Re: Supplemental Comments to the Final PEIS/R Based on New Information from the San Joaquin River Exchange Contractors Water Authority and the San Joaquin River Resource Management Coalition

San Joaquin River Restoration Program

FIGURE 17.—Land subsidence, 1926-72, Los Banos-Kettleman City area. Compiled as sum of subsidence for 1926-69 (fig. 15) and for 1969-72 (fig. 18).

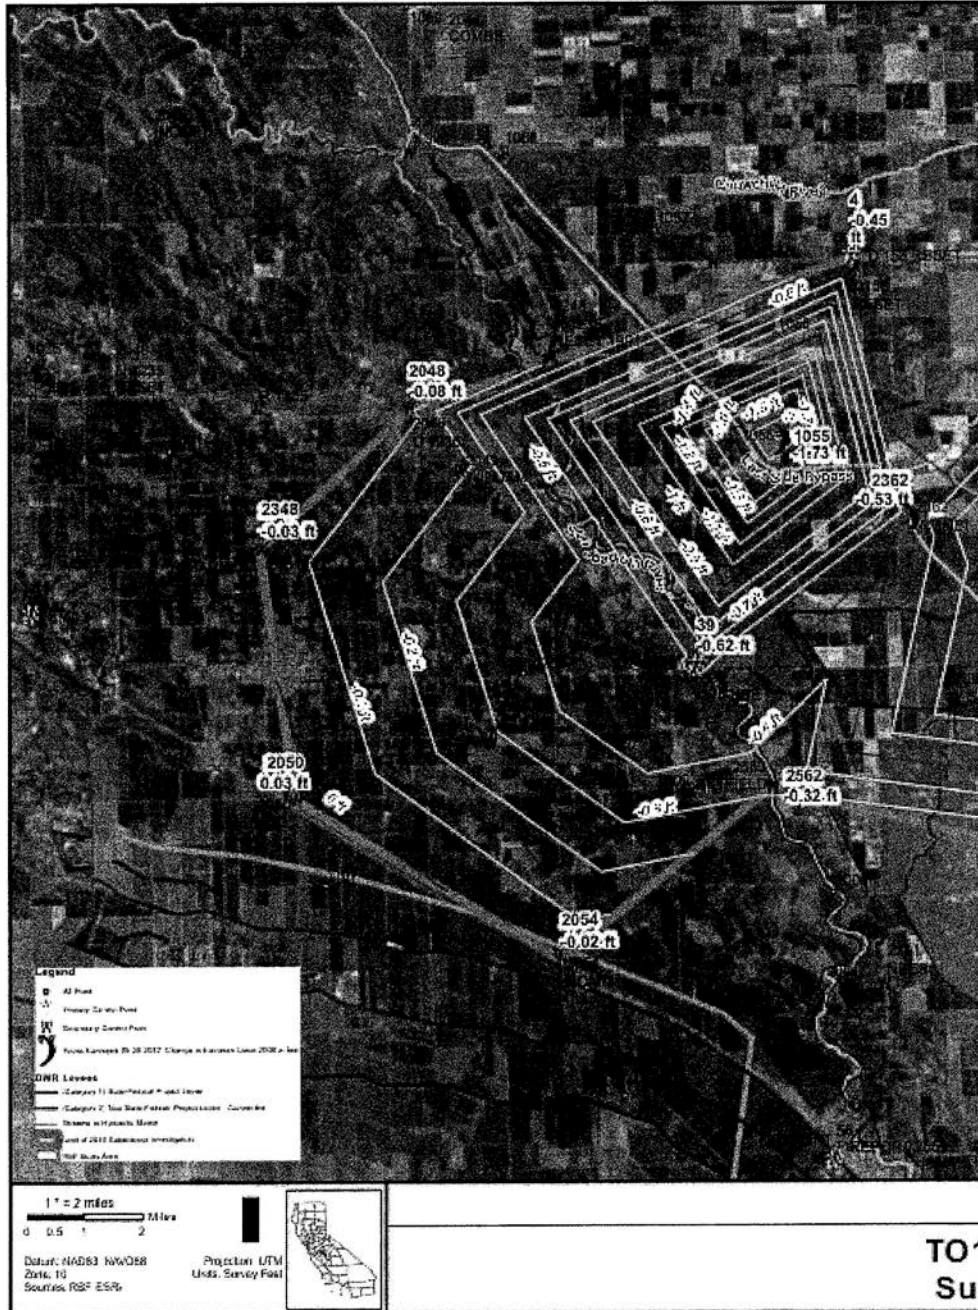
city of Mendota experienced over 28' of land subsidence from 1926 to 1972. Phase 1 facilities and river reaches that will be impacted include:
